UNITED STATES PATENT AND TRADEMARK OFFICE

APPLICATION NO.	FILING DATE	FIRST NAMED INVENTOR	ATTORNEY DOCKET NO.	CONFIRMATION NO.
09/516,753	03/01/2000	Gregory Pinchasik	2390/49701	3706

Office Action Summary

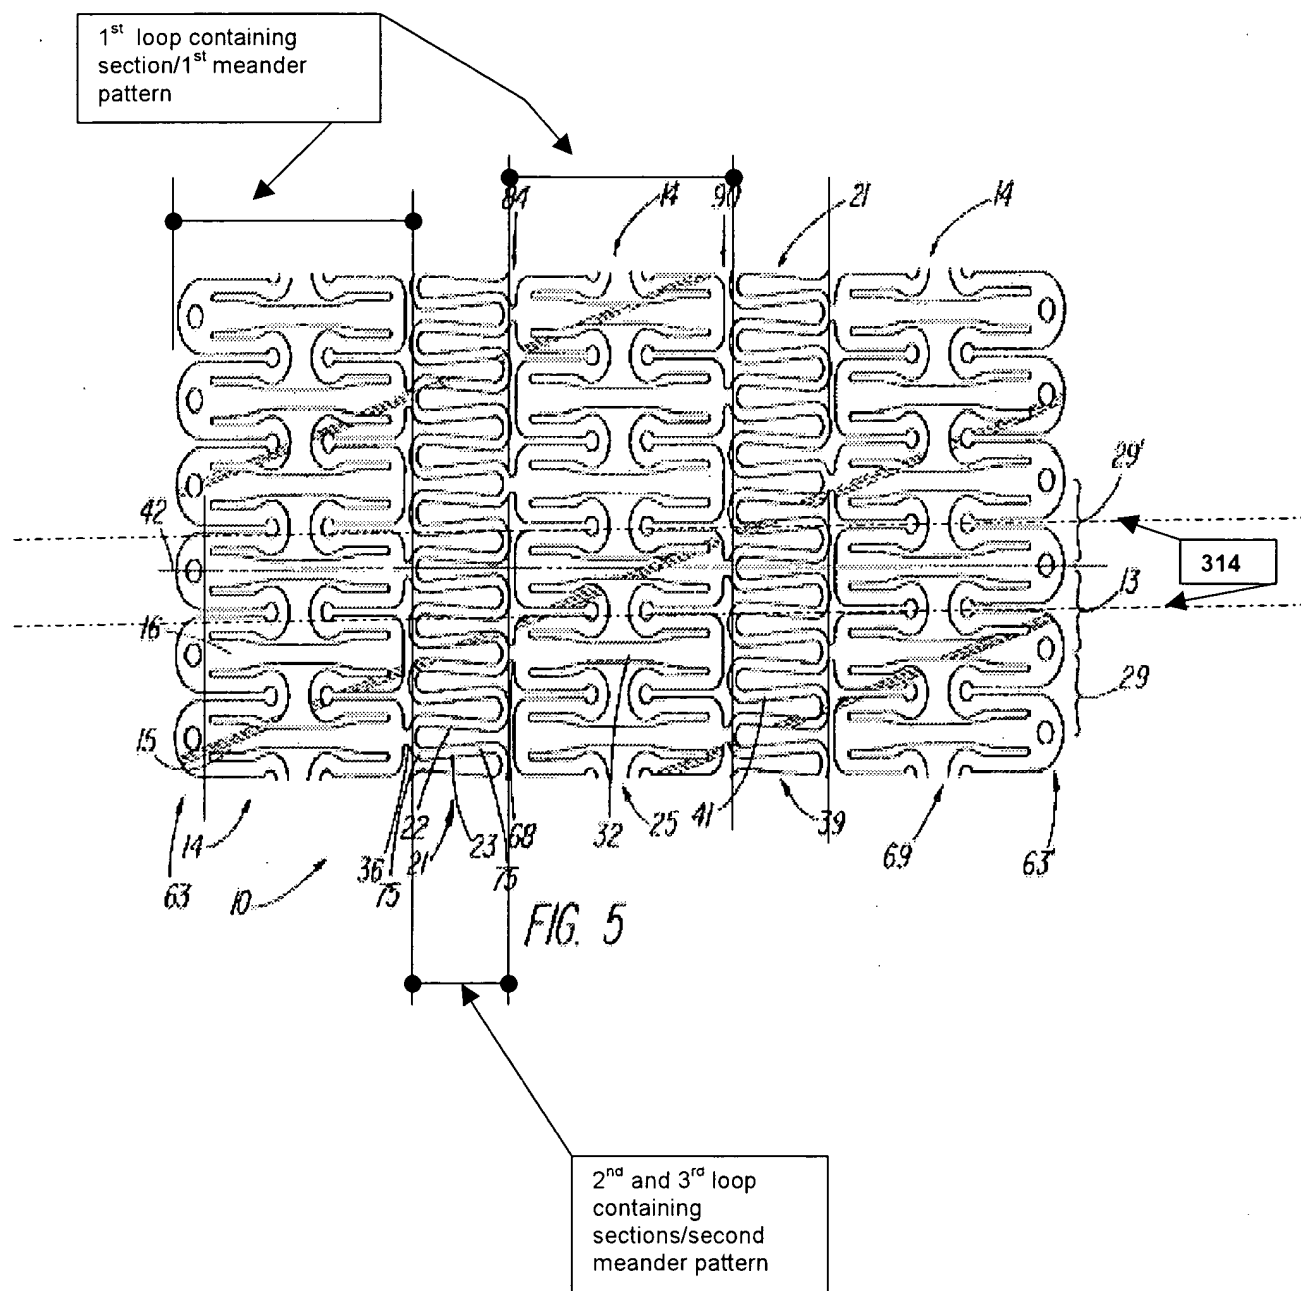
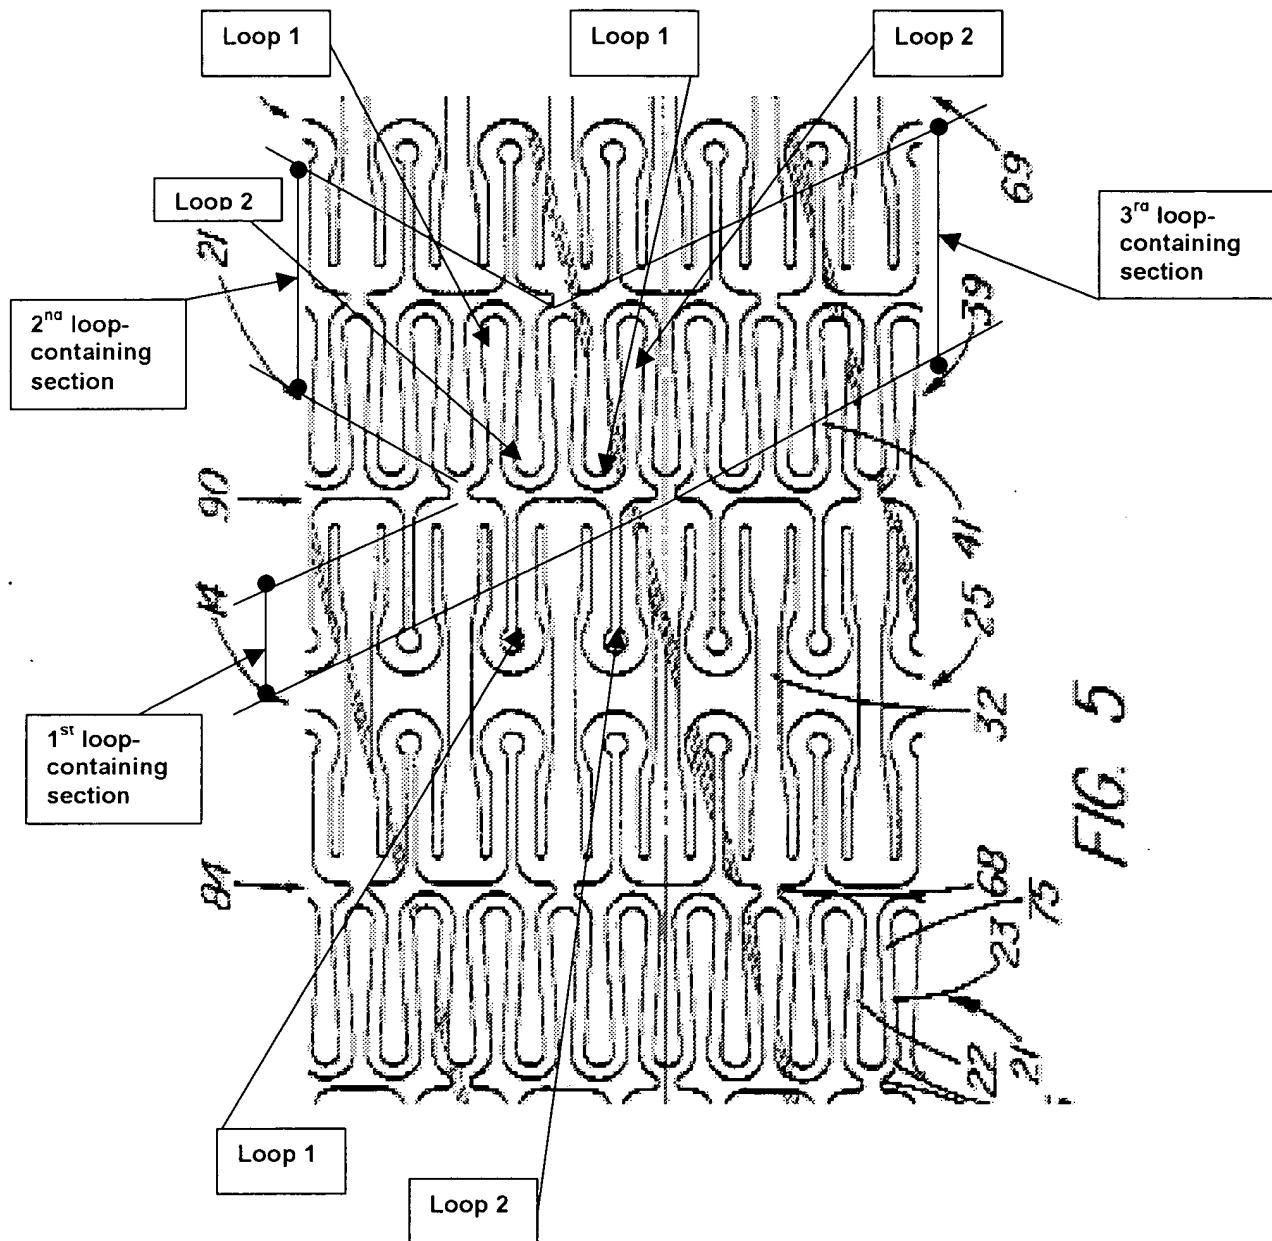
BERRY (Figs. 5 as shown below, for example) discloses a stent of stainless steel or nitinol:

As to claims 1-7, 9-10 and 45, BERRY (Fig. 5, page 4 this paper) discloses: 1<sup>st</sup> loop-containing section (highlighted in brown), 2<sup>nd</sup> loop-containing section (green) and 3<sup>rd</sup> loop-containing section (purple). The 1<sup>st</sup>, 2<sup>nd</sup> and 3<sup>rd</sup> loop-containing sections form triangular cells (highlighted in yellow), wherein each cell covers the same area. Notice that 1<sup>st</sup> loop-containing section has wider struts than the 2<sup>nd</sup> and 3<sup>rd</sup> loop-containing section, each loop-containing section has two loops, 1<sup>st</sup> and 2<sup>nd</sup> junction points are circumferential aligned.

As to claims 21-25, 27-28, 31-33, 37-46, and 48—50, BERRY (Fig. 5, page 3, this paper) discloses vertical meander/first meander pattern (highlighted in red) with

centerlines 301 and horizontal meander/second meander pattern (in green) with centerlines 314. The centerlines 301 of the vertical meander/first meander pattern are orthogonal to the centerlines 314 of the second/horizontal meander patterns. The vertical/first meander patterns include even vertical/first meander patterns 310e and odd vertical/first meander patterns 310o. The second/horizontal meander patterns include even horizontal/second meander patterns 312e and odd horizontal/second meander patterns 312o. Notice that the first/vertical meander patterns have two loops per period and the second/horizontal meander patterns have 4 loops per period as shown.

**FIG. 5 (for reference of claims 67-92)**

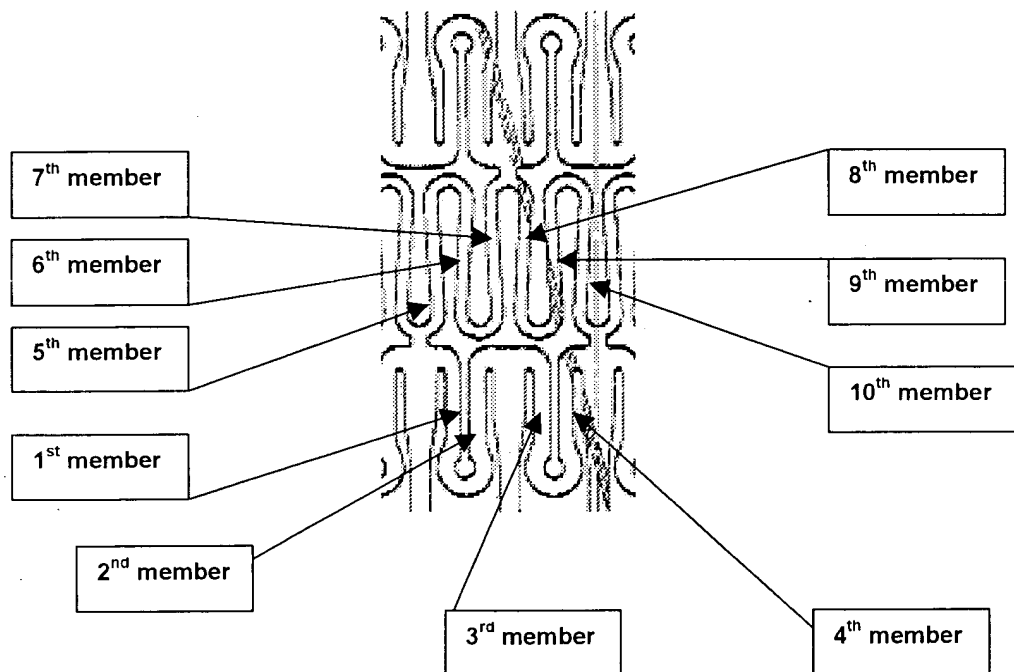
As to claims 67-70, 72-75, 77-81, 83-84, 86-88, and 90-91, BERRY (Fig. 5, this paper) discloses stent of stainless steel or nitinol having 1<sup>st</sup>, 2<sup>nd</sup>, 3<sup>rd</sup>, 4<sup>th</sup>, 5<sup>th</sup>, 6<sup>th</sup>, 7<sup>th</sup>, 8<sup>th</sup>, 9<sup>th</sup>, and 10<sup>th</sup> members which are interconnected as recited in the claims. The curved junction portions of the members define loops (shown in Fig. 5, page 6) as recited in the claims.

**(For reference to claims 95-119)**

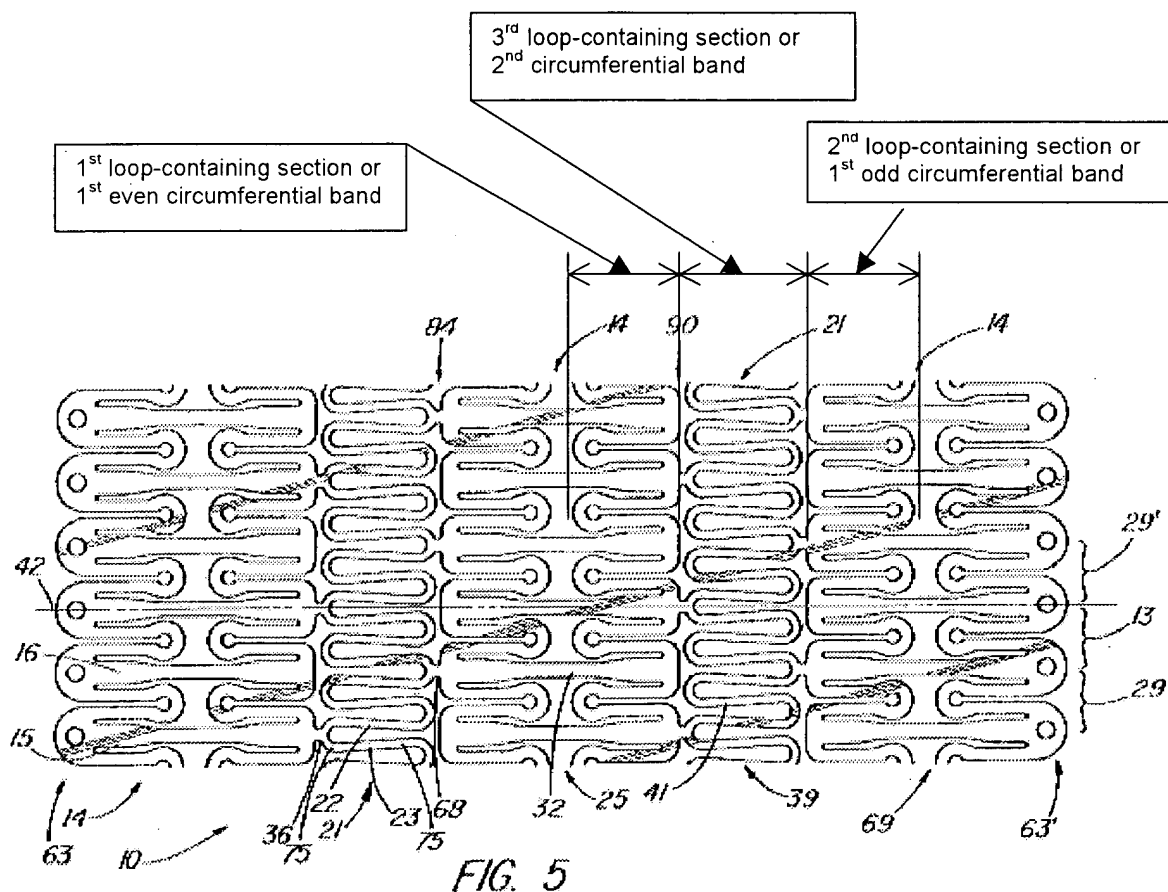
As to claims 95-104, 106-114, and 115-117, BEERY (Fig. 5, also Fig. 5 on page 7, this paper) discloses an even first loop containing section 301e/first circumferential band, an odd first loop containing section 301o/first circumferential band and third loop containing section/second circumferential band disposed between the first and second loop containing sections. The first or second loop containing sections (or the first circumferential band) and the third loop containing section (or the second circumferential band) defines loops as recited in the claims.
